West Capital Airpark Phase 1B-2 Residential (Novatech Phase 2B) Stormwater Management Report

**West Capital Airpark – Phase 1B-2 Residential
1500 Thomas Argue Road
Ottawa, Ontario**

**Reference: West Capital Airpark – Phase 1B-2 Residential
Stormwater Management Report
1500 Thomas Argue Road, Ottawa
Our File No: 102085
City File No.: D07-16-22-0017**

This report has been revised to address comments from the City of Ottawa as indicated in the cover letter. The City review comments and response to comments are included in **Appendix A** for reference.

PROJECT NO.: 102085
REV: #7
DRAWING NO.: 102085-GR13

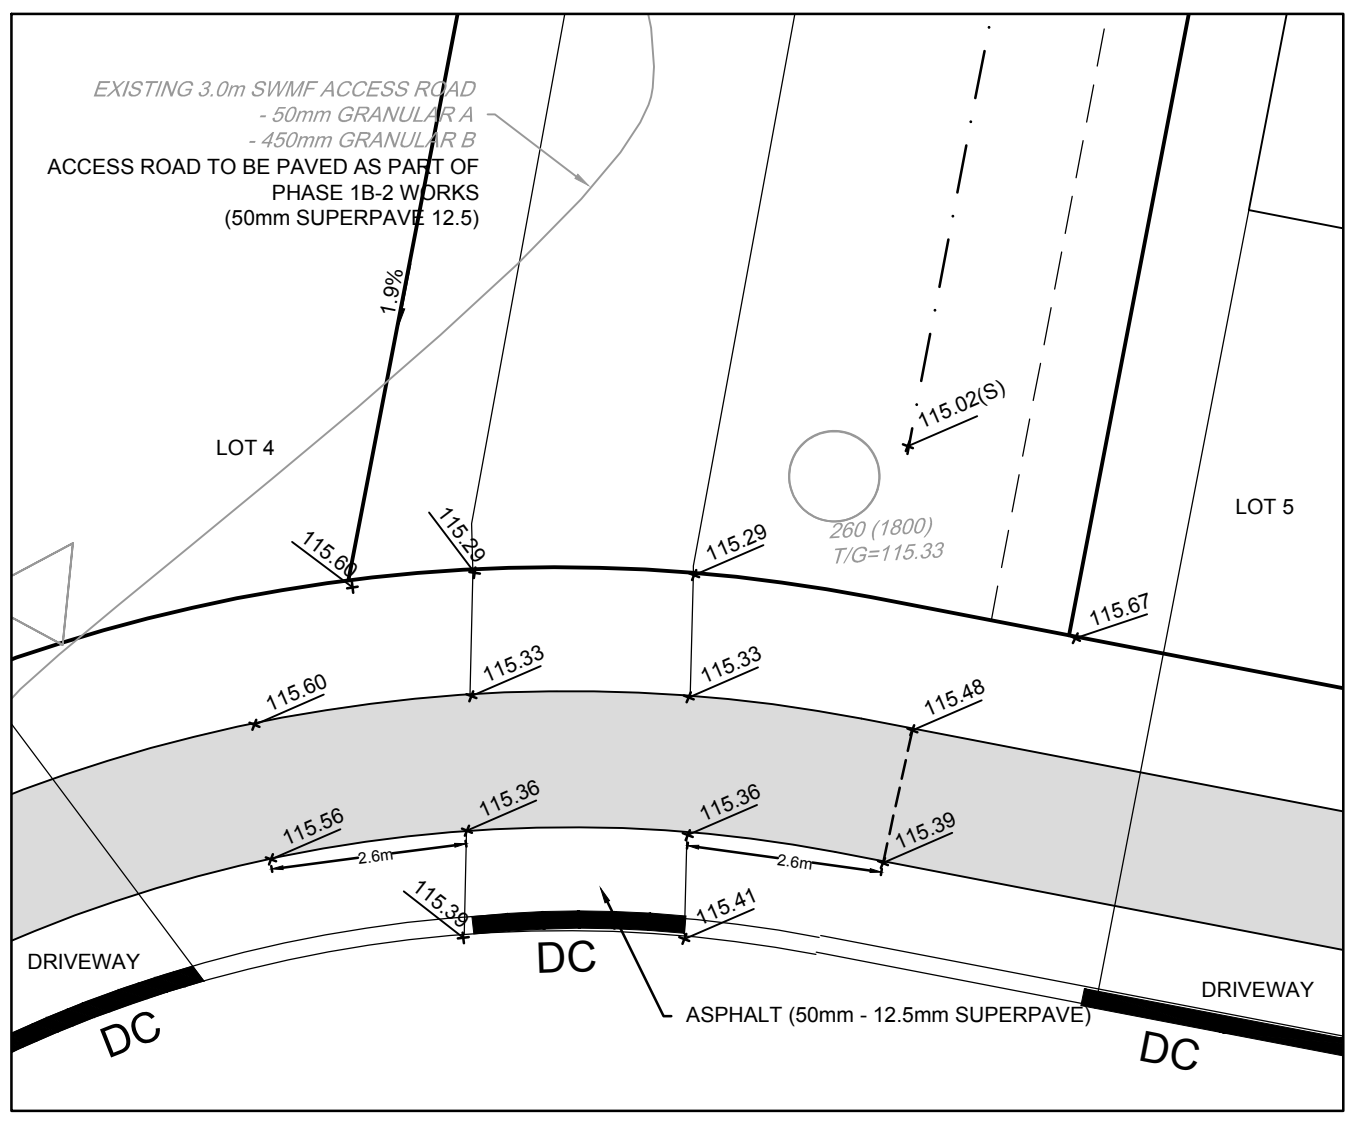
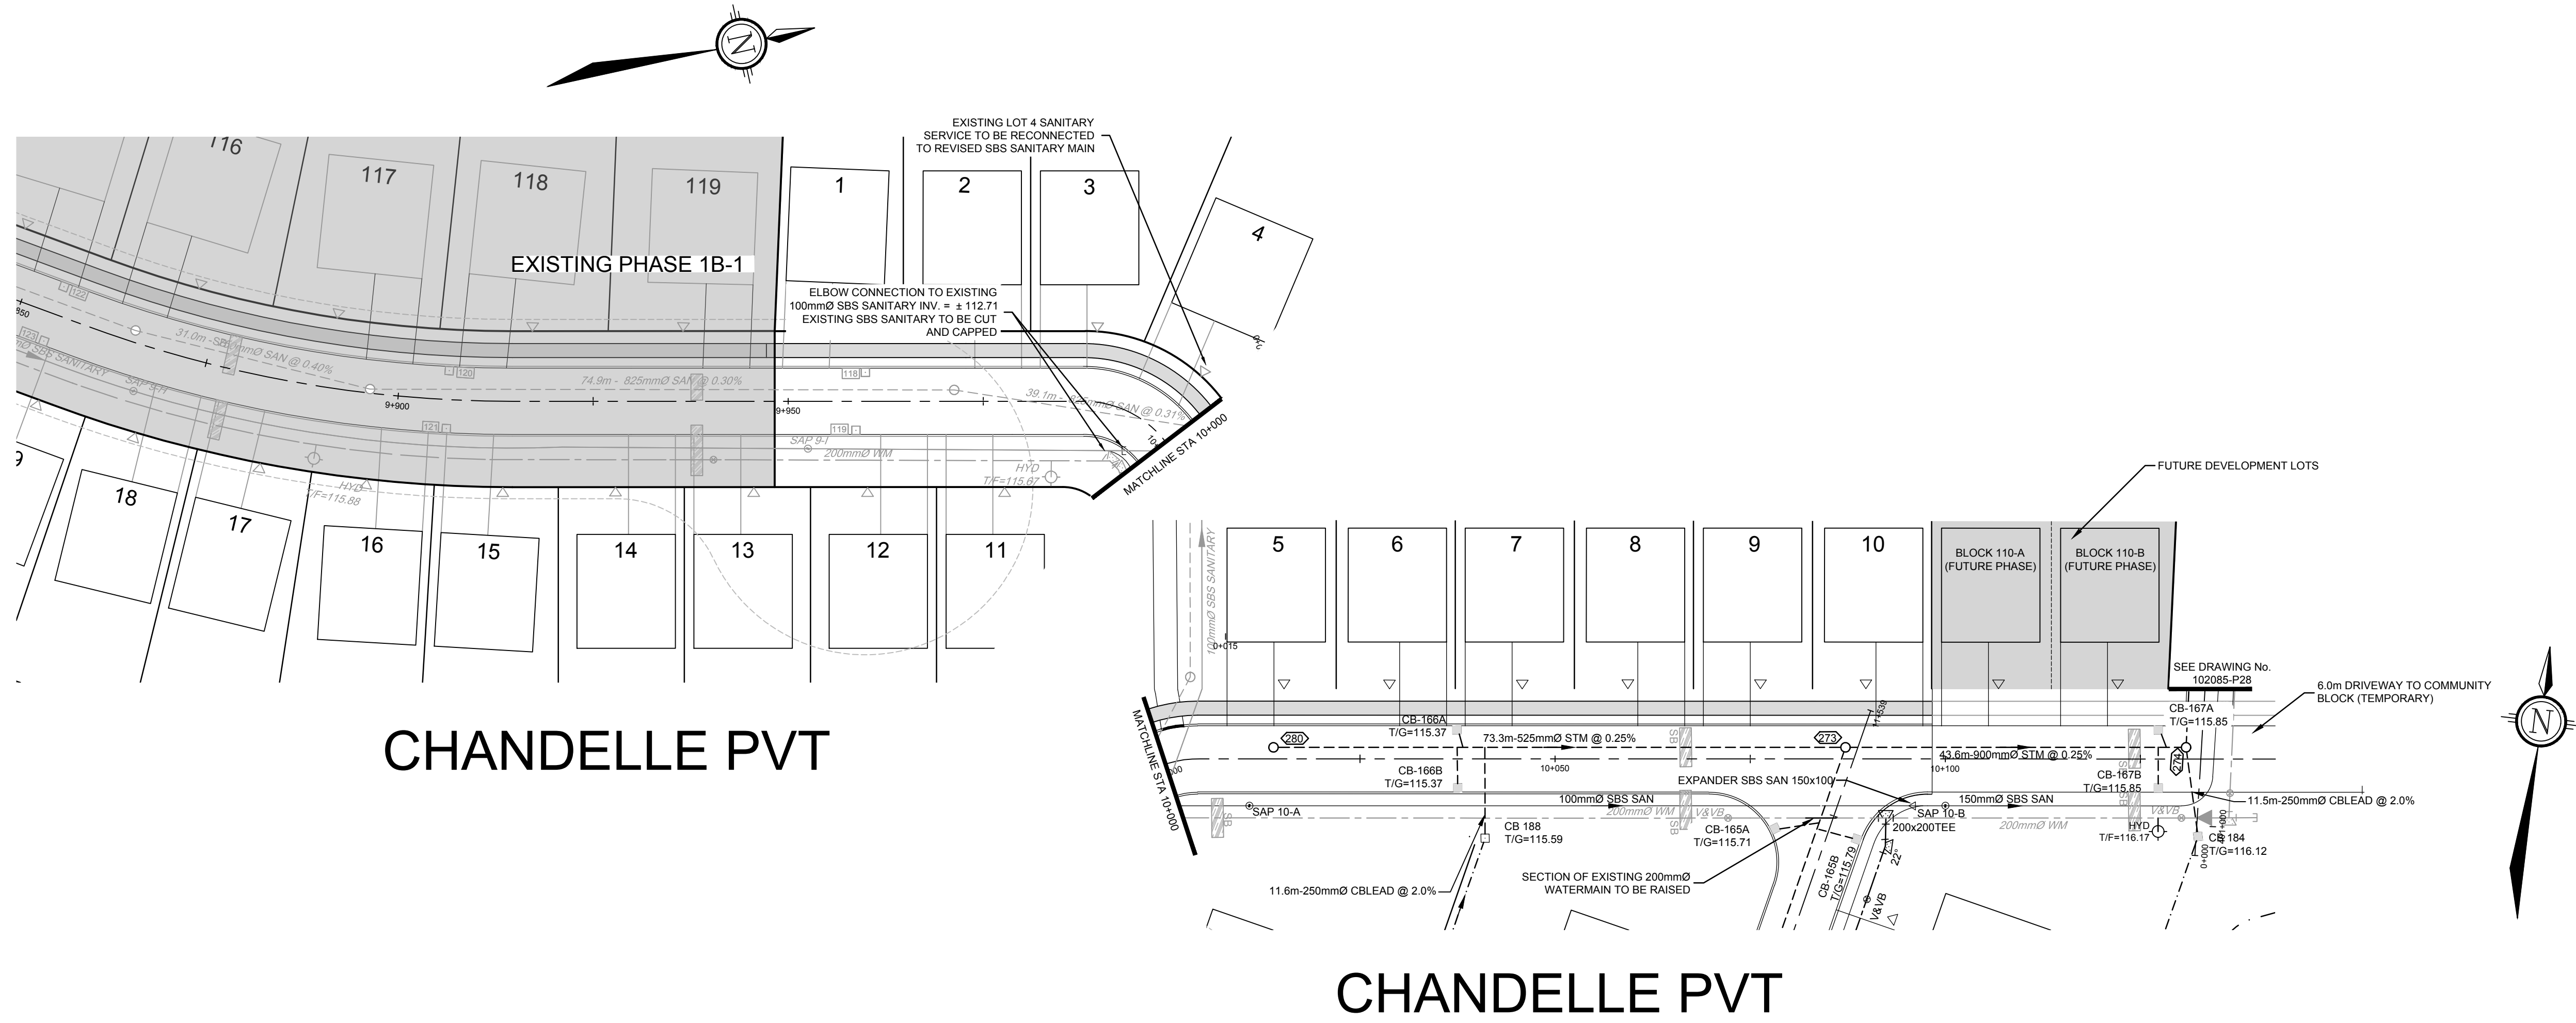
Grading Plan (102085-GR13)						
1	The asphalt service road beside the Vortech Unit should be extended to the Unit to facilitate parking of a vacuum truck.	General			Refer to the Grading Plan (102085-GR14) for asphalt limits, which are shown around the Vortech unit to facilitate parking.	
2	Arrows indicating the major flow pointing towards the CB 184; please provide a detail of the major flow channel entering the easement/block 81 towards the depression riprap.	General			The access road to SWM Facility will act as a major flow channel through Block 81. Refer to details on drawings 102085-GR14 and 102085-SWMF5.	
3	The temporary ditch and major overland swale are discharging into a rip-rap depression where dimensions are not provided. The maintenance access for this feature is required.	General			Rip rap dimensions have been added to the 102085-SWMF5 drawing. Access to this feature is via the asphalt access area provided to the OGS unit.

9.	Show rear yard ponding and in the interim swale on the plans.	Static ponding contours have been added to the Grading Plans.	No further comment.
10	The spill elevation 116.33 behind lot 63 appears to be higher than the overflow to the undeveloped land set at 116.29. It would be a better if all the overflows to the adjacent lands were at least 15 cm higher than the internal spill elevation along the swale.	The Lot 63 corner elevation has been revised. Refer to Grading Plan 102085GR14.	No further comment.
11	Profile drawing P28 show 1650 mm outlet 112.36 m then a slope down to the pond. Please extend the profile through the pond and out.	Additional pond details are provided on drawings 102085-SWMF5 and 102085-SWMF6. The approved design drawing for the existing pond has been included and provides a profile through the pond. Refer to drawing 102085-SWMF2.	No further comment.
12	GR14, top left-hand corner, is the spill point drawing for Block 83?	Yes. Name of detail has been updated to refer to Block 83.	No further comment.

PROJECT No. 102085
 REV # 9
 DRAWING No. 102085-P28

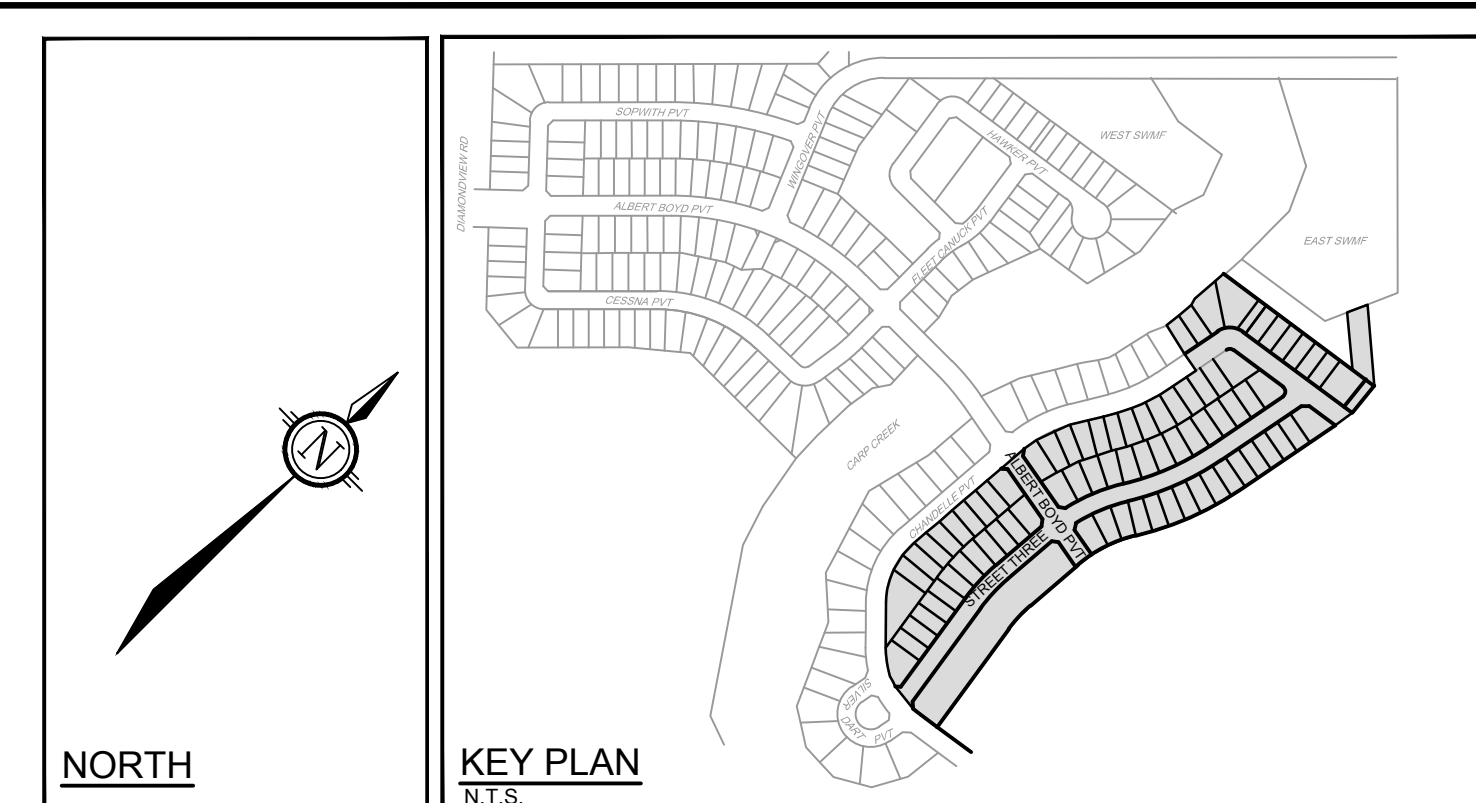
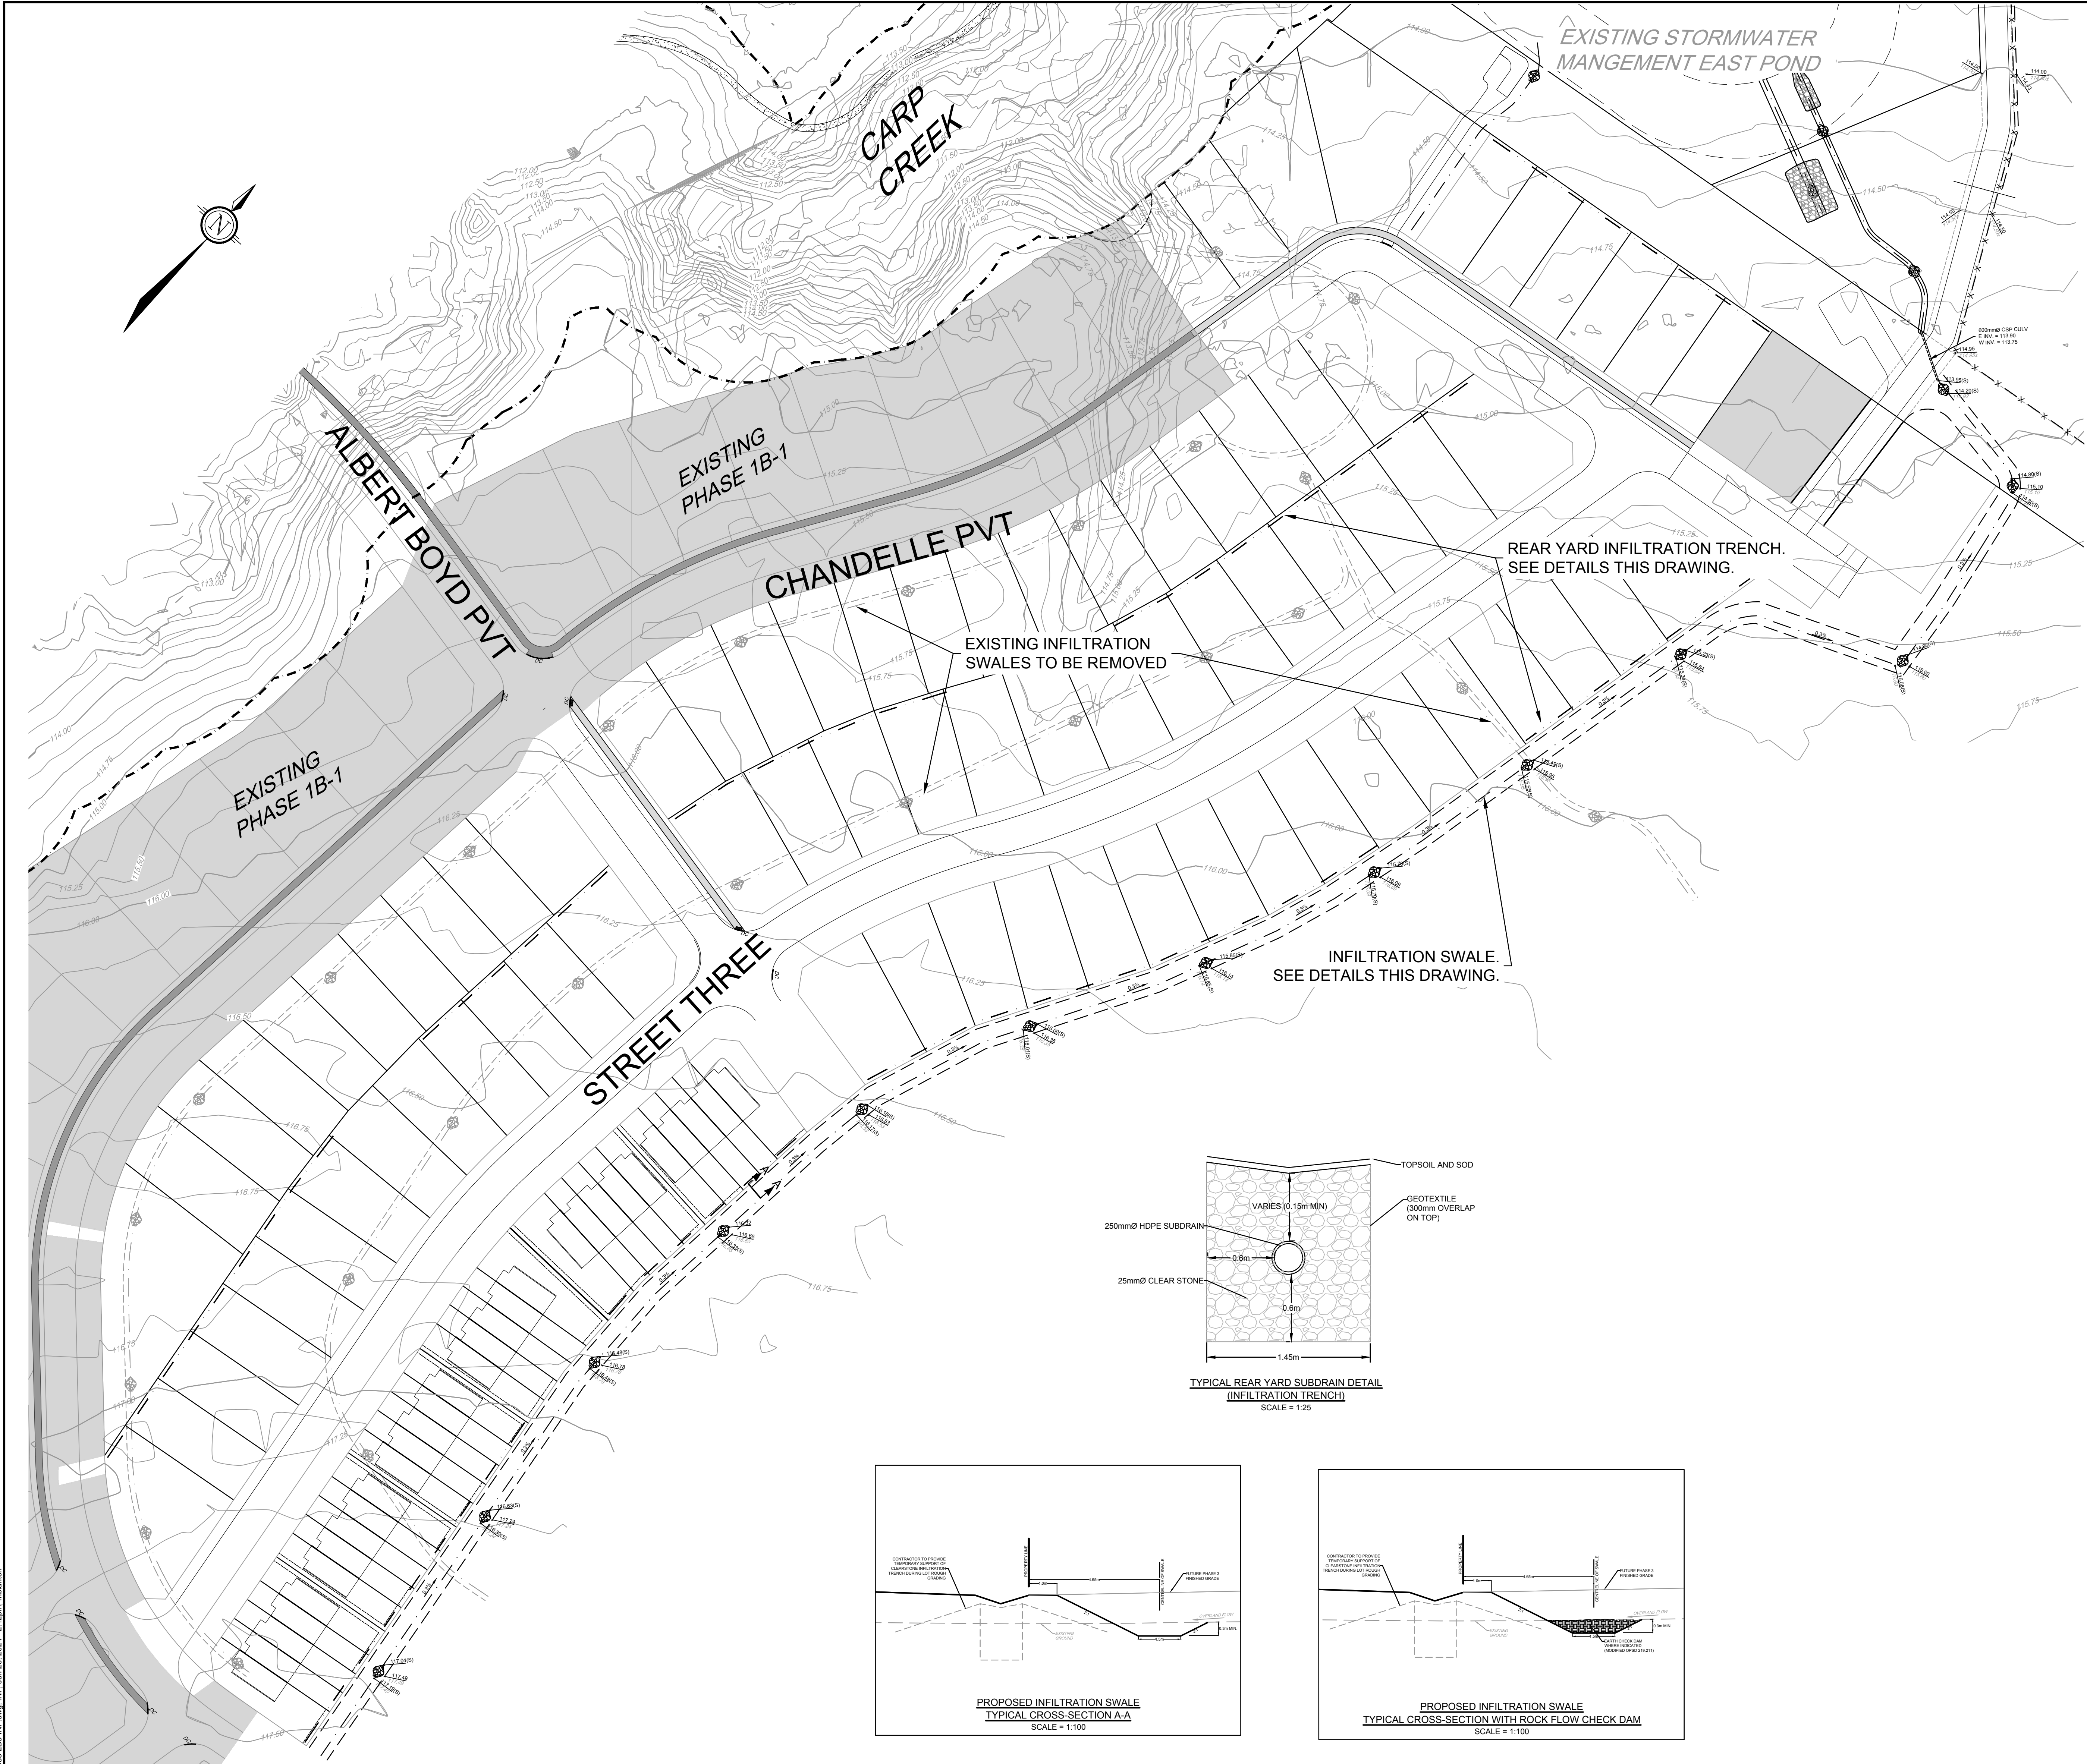
11. Profile drawing P28 show 1650 mm outlet 112.36 m then a slope down to the pond. Please extend the profile through the pond and out.
12. GR14, top left-hand corner, is the spill point drawing for Block 83?

Plan and Profile Phase 1B-2 Block 81 & Storm Sewer Outlet (102085-P28)						
1	Usually, upstream pipes are design to meet or exceed downstream pipe obverts and not as the profile indicated on the design drawing.	General			See response to General comment 2.	
2	Can you please provide us with DWG. SWMF 6 detail since the profile is incomplete.	Pond Inlet & RipRap			Additional pond inlet details are provided on drawings 102085-SWMF5 and 102085-SWMF6.

- The profile drawing for Block 81 (drawing 102085-P28) still includes offline exfiltration units. There are a few more references to exfiltration in legends and notes on various drawings. Please remove references to exfiltration units that are not part of the proposed SWM plan.

3			The profile drawing for Block 81 (drawing 102085-P28) still includes offline exfiltration units. There are a few more references to exfiltration in legends and notes on various drawings. Please remove references to exfiltration units that are not part of the proposed SWM plan.	The exfiltration trench has been removed from profile drawing 102085P28.	OK
